STAFF RECOMMENDATION

1814 Shelby Avenue

July 15, 2020

Application: New Construction—Outbuilding (Detached Accessory Dwelling Unit);
Setback Determination

Figure 3: Side street elevation, indicating the eave height benefiting from the change in ground level. Also see Figure 2 for existing conditions.

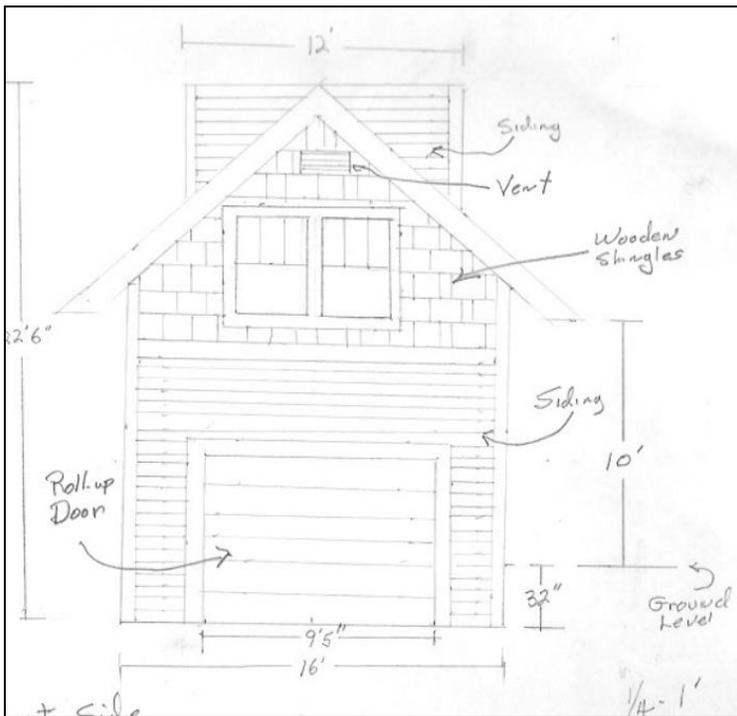
The proposed square footage of the outbuilding is four hundred and ninety-six square feet (496 sq. ft.) which is an appropriate footprint for the lot, which is seven thousand, four hundred and thirteen square feet (7,413 sq. ft.). The overall height of twenty-two feet, six inches (22' 6") is compatible with the twenty-five foot (25') ridge height of the house. The existing pad is at the street level. However, the yard has a retaining wall thirty-two inches (32") higher, so the eave height as drawn is twelve and a half feet (12 ½ ') from the grade on which the structure is built (See Figure 2 and Figure 3). Staff recommends that the eave height not exceed ten feet (10') from the grade on which the outbuilding is built. With this condition, the height, eave height and footprint meet the design guidelines for height and scale.

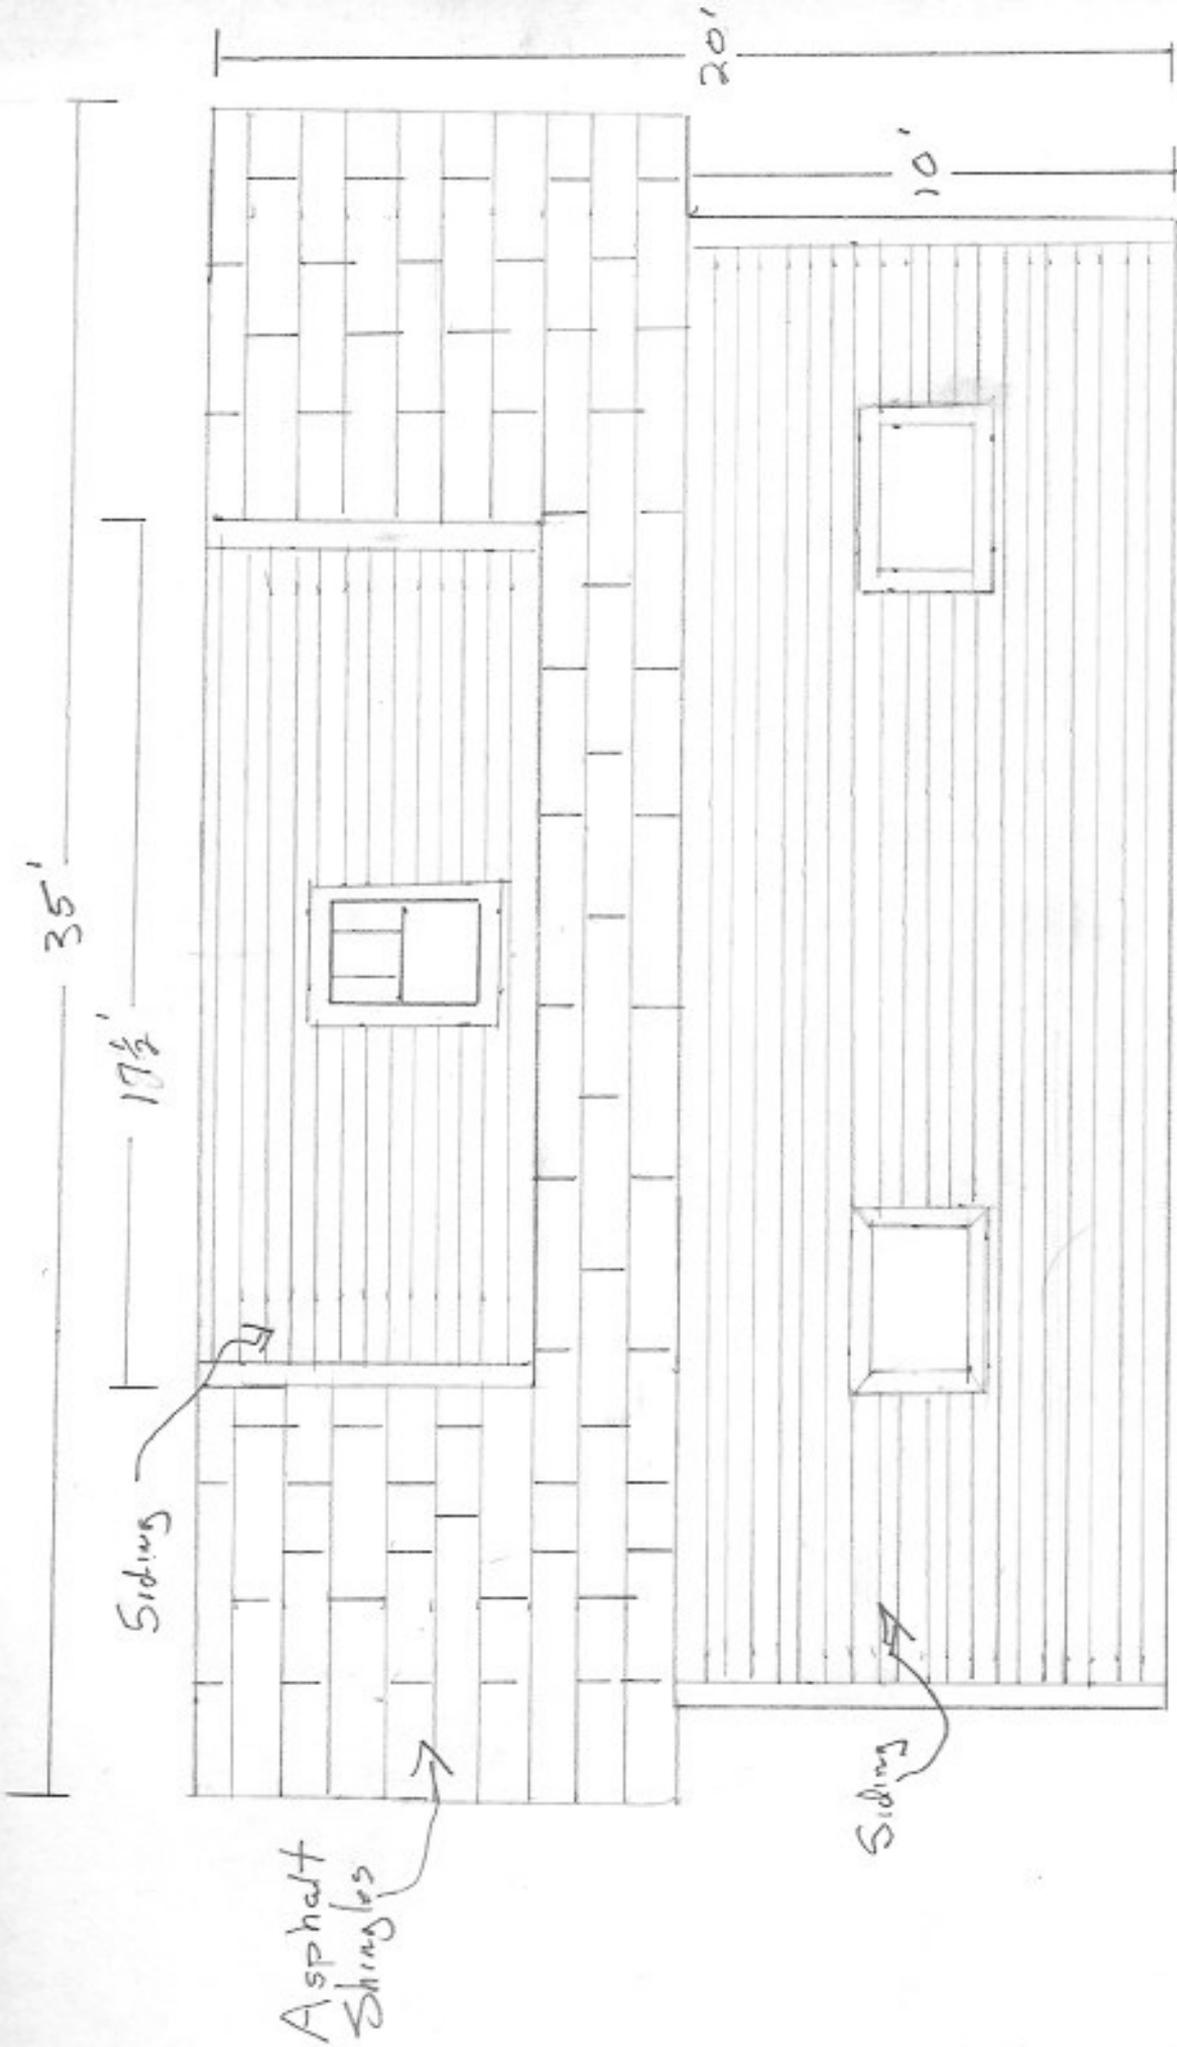
The applicant requests a setback determination for the left side setback, facing 19th Street, for the requested zero feet (0') to the side property line. Base zoning requires a twenty-foot (20') setback when garage doors face the side street. In addition, Section II.B.8 on Outbuildings specifies that for a corner lot, the setbacks of a new outbuilding should match the context of homes on the street, when there is historic context. The Commission has reduced setbacks for outbuildings on corner lots to as little as ten feet (10'). The existing historic home on the lot has a setback of twelve feet (12'); therefore, a setback for the outbuilding of twelve feet (12') could be appropriate. Staff finds that an outbuilding that sits on the side property line not only does not meet the design guidelines, but also could create unsafe conditions for pedestrians on the sidewalk and cars driving down the alley. One reason for the deeper side setback for corner lots is that cars driving down the alley to exit onto South 19th Street need to be able to see oncoming traffic. A garage that is on the side property line will obscure views of the street from the alley.

Additionally, on a lot with alley access, any additional access is generally required to be from the alley and not from the public street. Metro Public Works has told MHZC staff that they would not support the driveway as proposed, as it accesses the street too close to the alley, creating an unsafe condition. Metro Public Works will only approve alley access. Because of the different concerns regarding the outbuilding's setbacks and site requirements, staff finds that the setbacks do not meet the design guidelines as proposed. The outbuilding, however, could be approved if it were accessed via the alley, with an alley setback of at least five feet (5') and a South 19th Street setback of twelve feet (12'), matching the side street setback of the historic house. Staff therefore recommends that the side street setback is increased to no less than twelve feet (12') from the side property line, and the rear setback (facing the alley) is increased to at least five feet (5').

1. The side street setback is at least twelve feet (12') matching the side setback of the historic home, and the rear setback (alley side) is increased to at least five feet (5');
2. The outbuilding is accessed from the alley and not the side street;
3. The dormers are revised to have at least a 2/12 roof slope and at least 50% glazing;
4. The eave height shall not exceed ten feet (10') from grade;
5. Staff have final review of materials, including windows, doors, garage door, roofing color, and cladding.

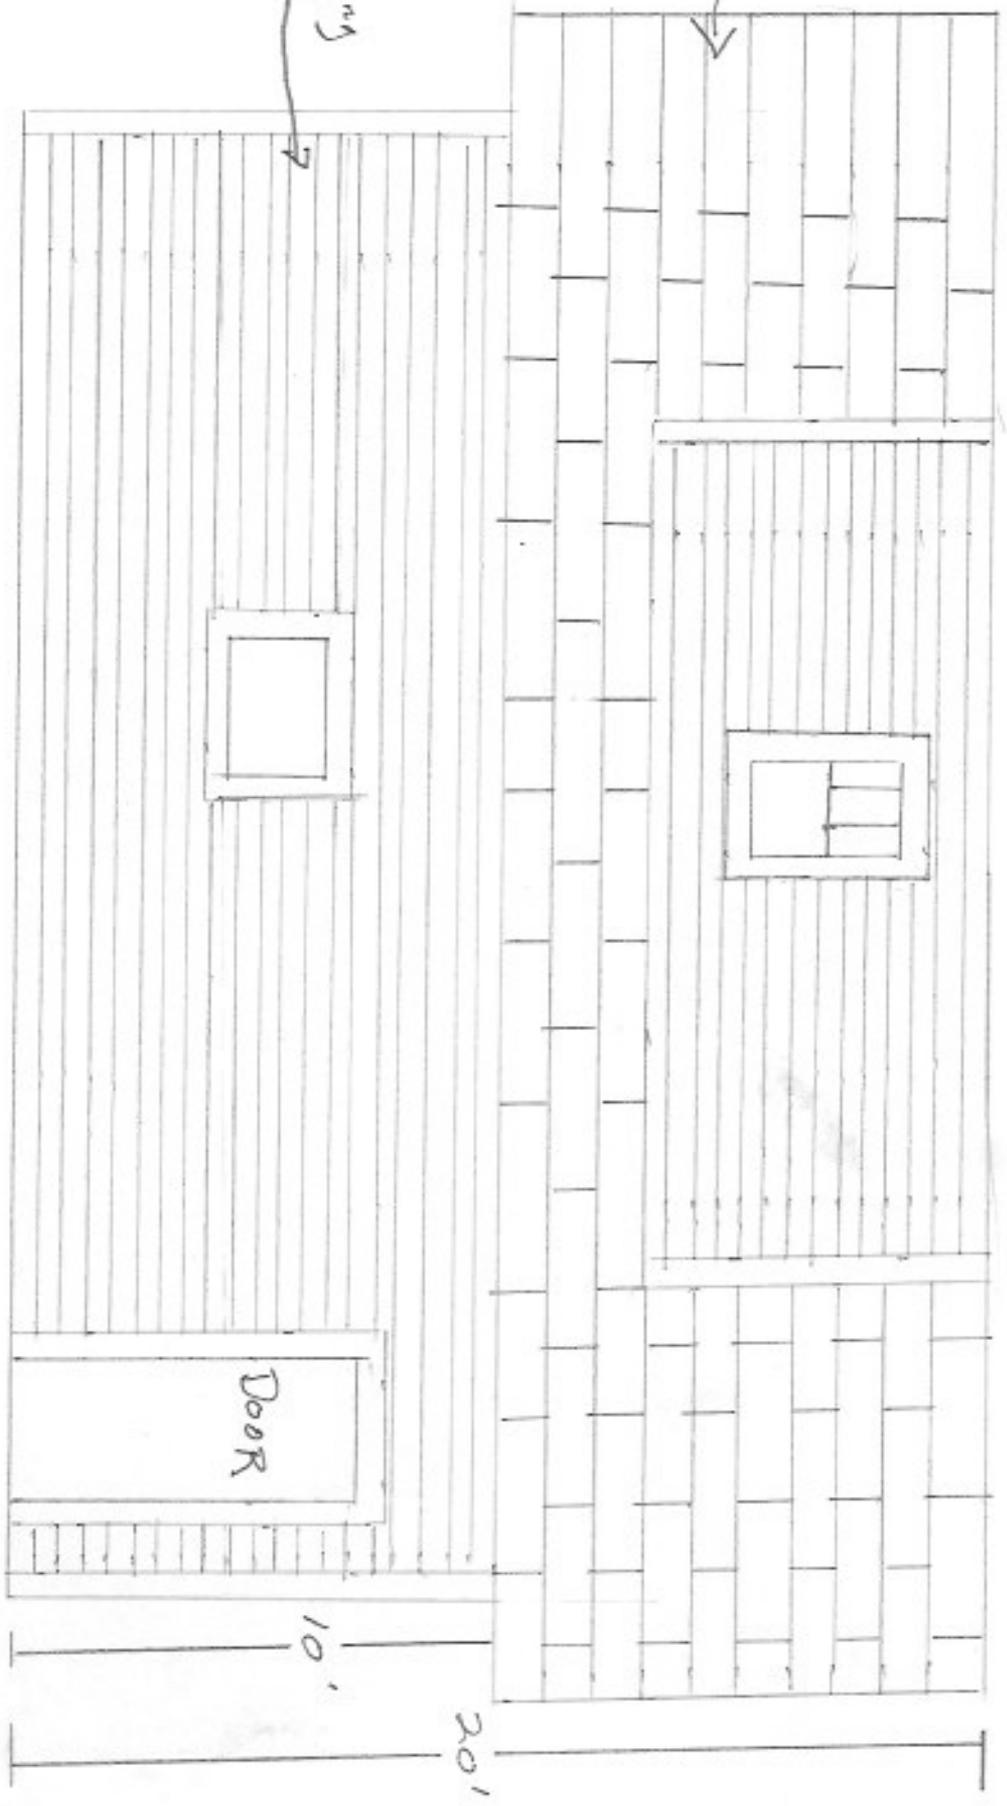
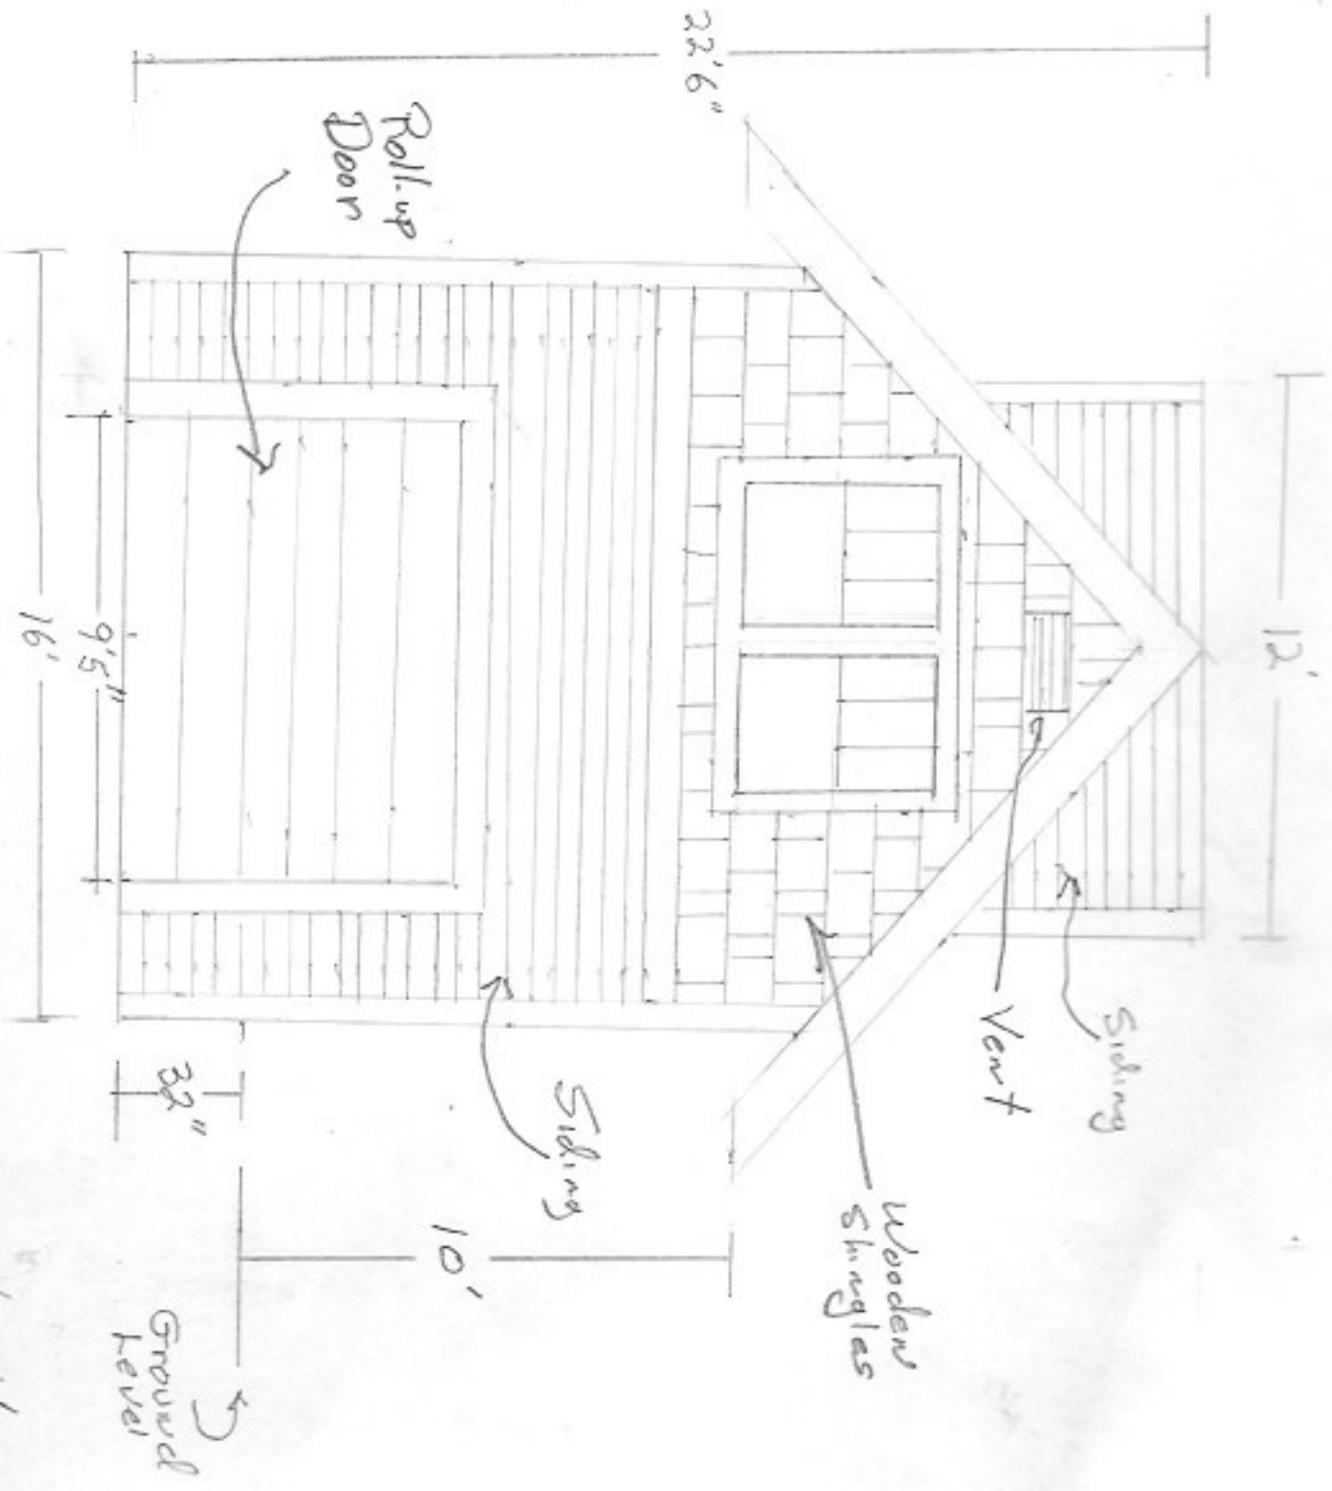
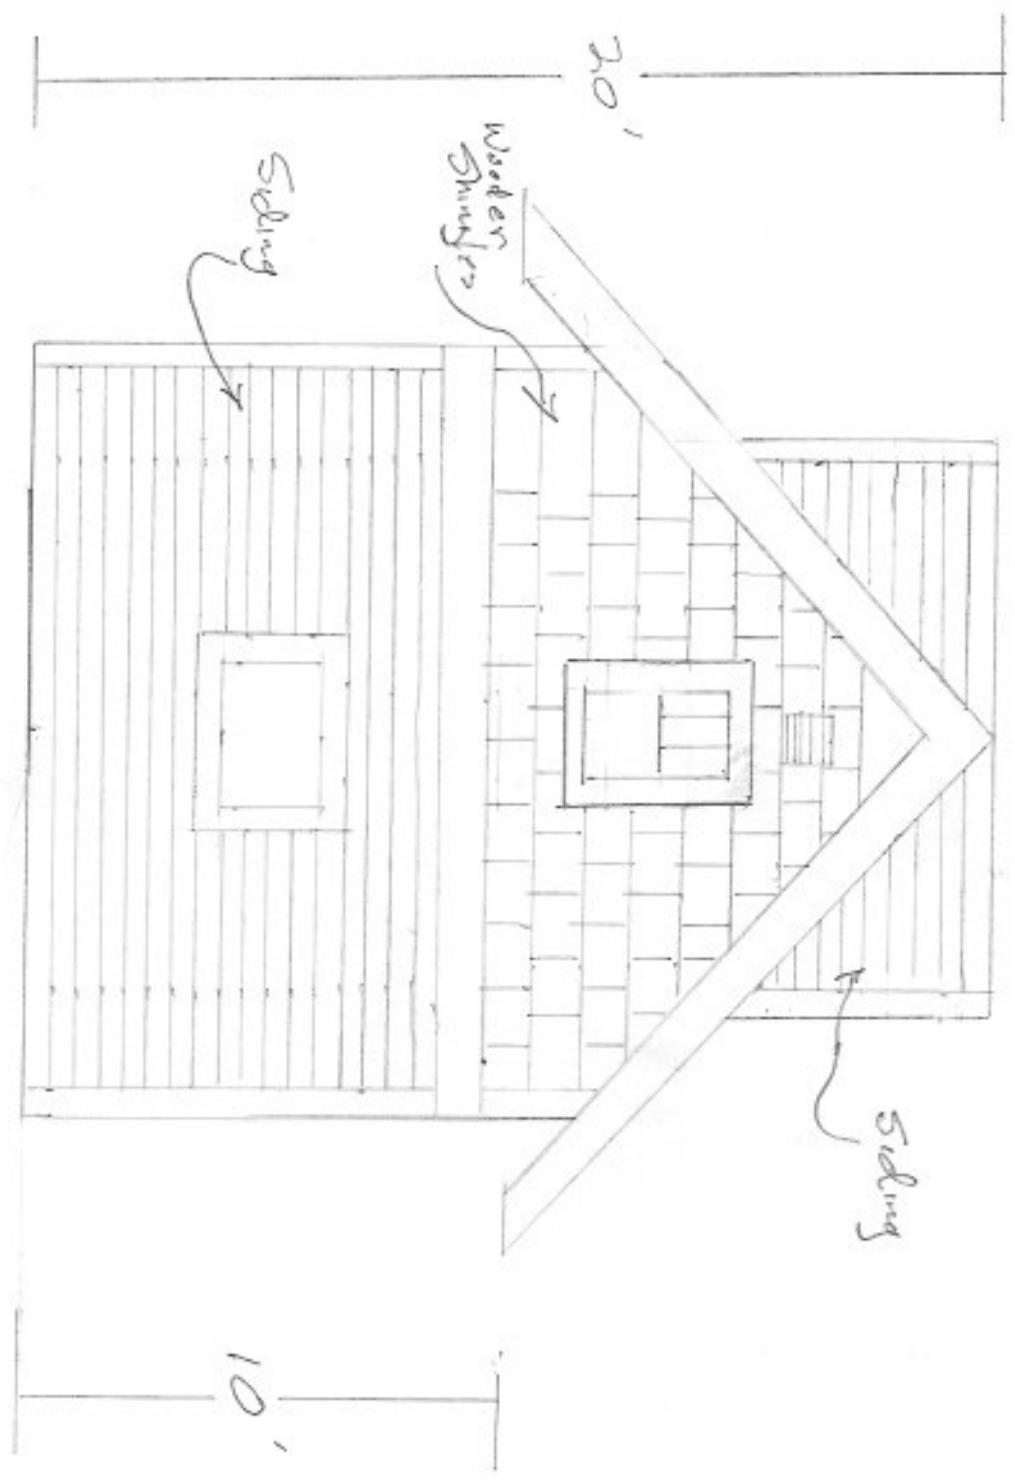
The proposed dormers inset two feet (2') from the wall below them. They have a flat roof form which is atypical and contrasts with traditional roof forms. They are also more wall than window, which is atypical of dormers historically. Dormers generally should have at least a 2/12 pitch and should be at least 50% glazing instead of wall. With the condition that the dormers are revised with at least 2/12 pitch, and the dormers have no less than 50% glazing, the application will meet section II.B.8 for roof form for outbuildings.
